Los Gatos Luxury Cars
Development Review Application
620 Blossom Hill Road, Los Gatos CA

TOWN OF LOS GATOS EXHIBIT 7
PLANNING DIVISION

RE: 620 Blossom Hill Road

ARBORIST REPORT

Original Design

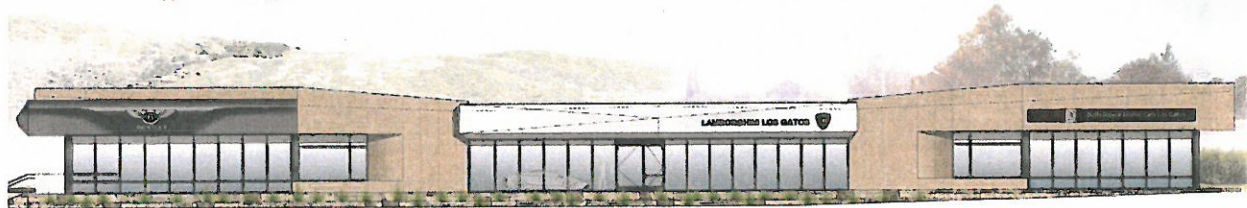
The proposed showroom design is for a single long, modern style structure with solid and glass walls. Although held to a relatively low height to partially mitigate view blockage to the distant hills, it will still be highly distinctive landmark-type of structure. Its landmark nature, however, has been refined since the initial submission, and seems like it will more comfortably fit within the Los Gatos town fabric. See the original proposal and current design illustrations below.

The building height has been lowered, the building skin materials and modulation of parapet heights has visually segmented the larger building into three distinct elements, and the treatment of the wall and glass surfaces at the end showroom has been greatly refined.

I have no recommendations for changes to the project design.

TREE MAP

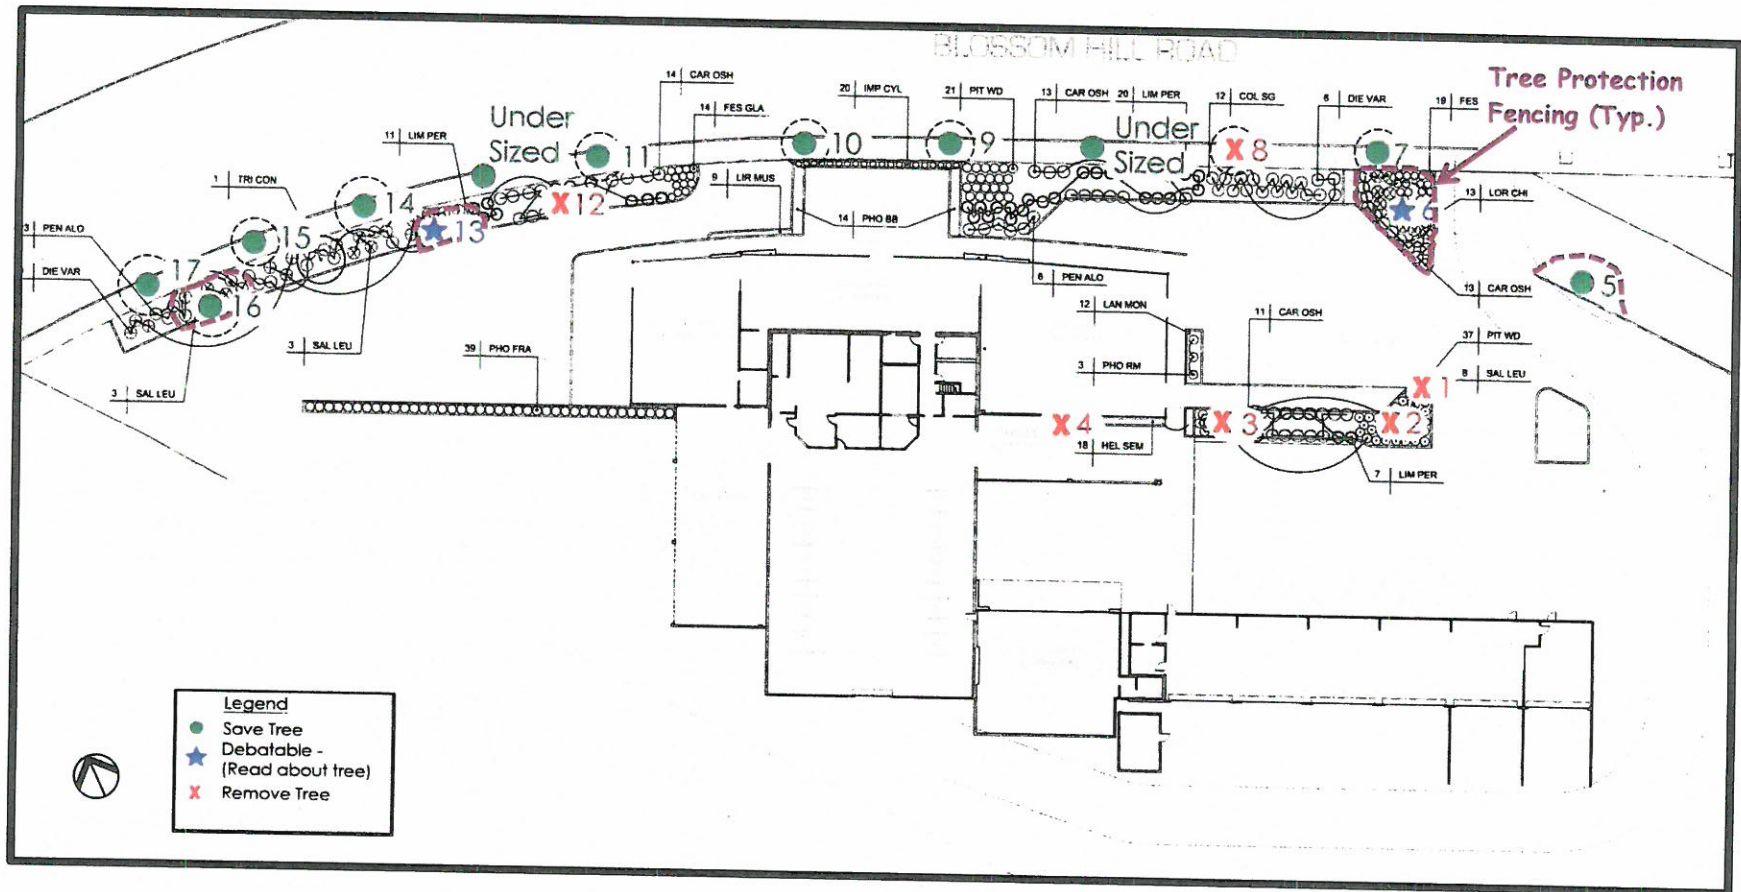
1. **Remove the following 6 trees: #1-4 Australian willows, #8 crape myrtle and #12 Brisbane box.**
2. **Save and protect the following 9 trees: #5, 7, 9-11 and 14-17.**

4. **Replace crape myrtle #8** (due to poor condition) with a new crape myrtle tree, as part of new landscaping.
5. **Tree Disposition Plan:** re-label the trees with the tree numbers used in this report. These are the actual numbers on the tree tags that were placed on these trees in the field. Also revise the Legend so that the tree tag numbers are used.

8. **Tree Disposition should match on all site-based plan sheets.** Some of the sheets vary in which trees will be saved or removed. On the demo sheets number the trees as per the tree numbers in this report and clearly show which trees will be removed. On the grading plan show the numbered trees and show which trees will be saved or removed. On the landscape and irrigation plans show the numbered trees that will remain.

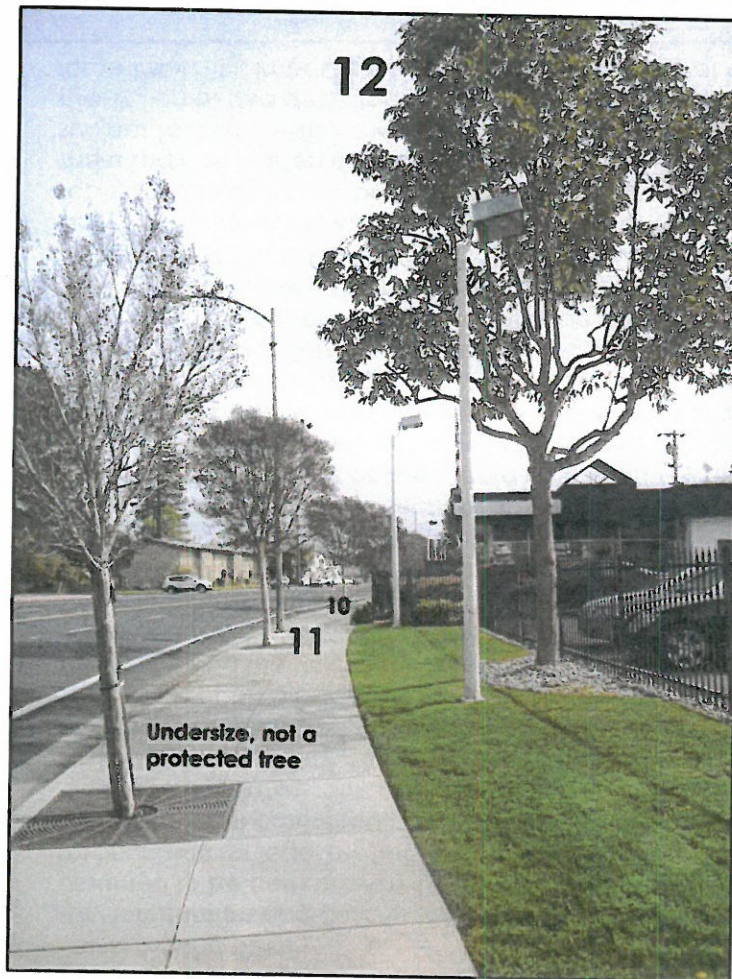
Left photo: crape myrtle street trees #7 and 8, with Australian willow #6 and Brisbane box #5 in the background.

Center: close-up of crape myrtle #8 with cracked trunk; this tree should be removed and replaced.

Left: close-up of crape myrtle #14 overgrowing tree grate.
